Proposed Edits for Discussion
Proposed Obey Creek Development Agreement
June 15th Public Hearing

Prepared by: Office of Planning and Sustainability, Town of Chapel Hill

Last revised: June 15, 2015

Revised Pages for “Exhibit J: The Village at Obey Creek Design Guidelines”

Type 2 Building Typology and Uses

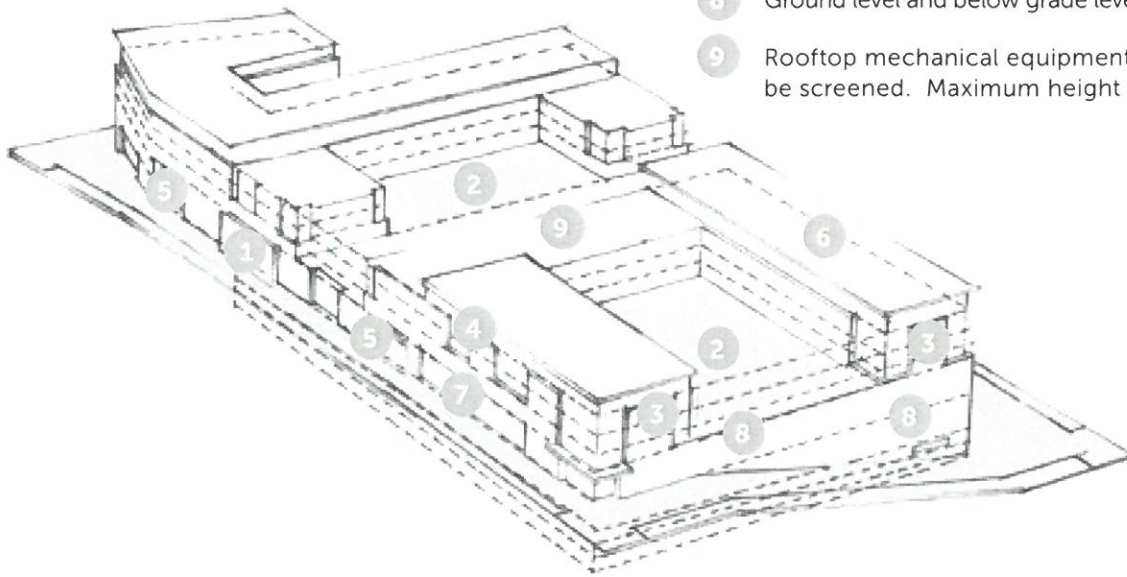
- 1 Ground level uses to be in-line, multi-tenant retail, commercial, residential amenities and may include parking
- 2 Residential single story level courtyards provide common open and recreational opportunities
- 3 Stacked apartment flats.
- 4 Building facade of the residential upper floors is to be a minimum of 30% glazing; building facade for the ground level retail to be a minimum of 70% glazing
- 5 Residential access to be provided from a lobby oriented to the public way
- 6 Flat roofs will be provided
- 7 Upper floor retail uses must provide a minimum of 20% transparency
- 8 Ground level and below grade level large scale retail
- 9 Rooftop mechanical equipment over 4' high to be screened. Maximum height will be 20'

Type 5 Building Typology and Uses

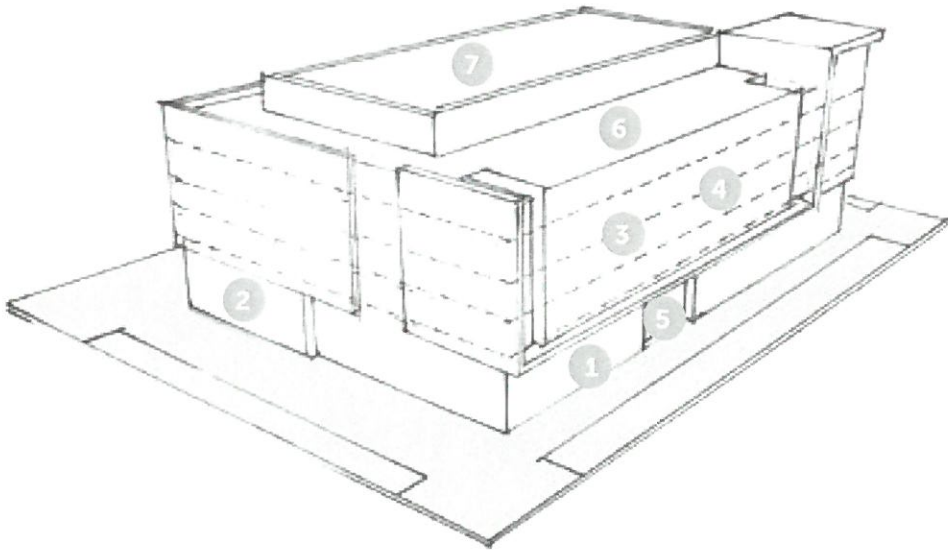
- 1 Ground level uses to be multi-tenant retail, commercial or service office with office support services
- 2 Parking to be provided in centralized common structure or below grade garage
- 3 Stacked office floor plates.
- 4 Building facade of the office upper floors is to be a minimum of 30% glazing; building facade for the ground level retail to be a minimum of 70% glazing
- 5 Office access to be provided from a lobby oriented to the public way
- 6 Most office structures are designed with flat roofs
- 7 Rooftop mechanical equipment over 4' high to be screened. Maximum height will be 20'

Building Heights and Sections

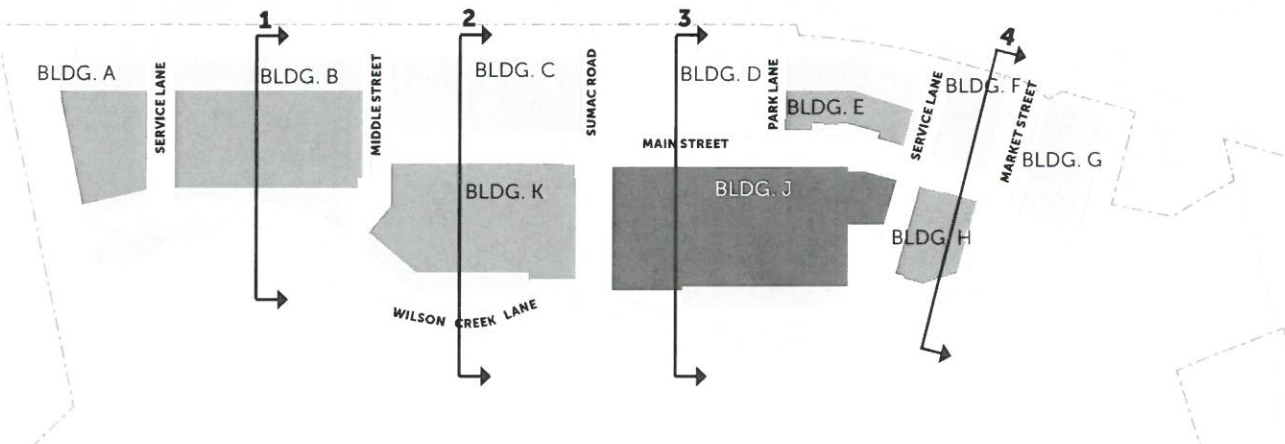
Mechanical Screens: Any rooftop mechanical equipment above 4' must be screened. The maximum height of any mechanical screen shall not exceed 20' above the adjacent roof.

All buildings that front onto US 15-501 shall have an absolute height (Including occupied floors, sloped roofs, and any other roof top equipment) of 70'-0" above the average grade along the face of the building that fronts onto US 15-501. Only decorative corner tower elements are allowed to exceed this height. These buildings shall adhere to the 4 story and 70'-0" height limit for a depth of 60'-0" from the face that fronts US 15-501. Areas of the building that are set back greater than 60'-0" from the faces that front onto US 15-501 may rise up to 6 stories in accordance with the building height diagram.

Parapet, Roof Screens, & Vertical Elements

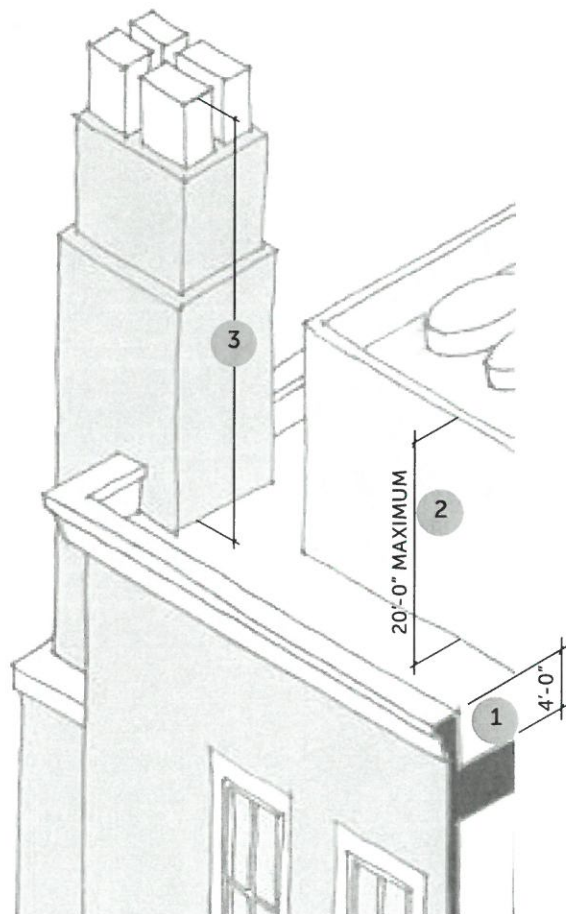
- 1 Parapets can occur at the perimeter of buildings and can not exceed 4'-0" above the roof.
- 2 Mechanical roof screens must exceed the height of the equipment they enclose but in no cases may they exceed 20'-0" above the roof.
- 3 Corner tower elements, vertical markers, and sloping roofs may be of any height.
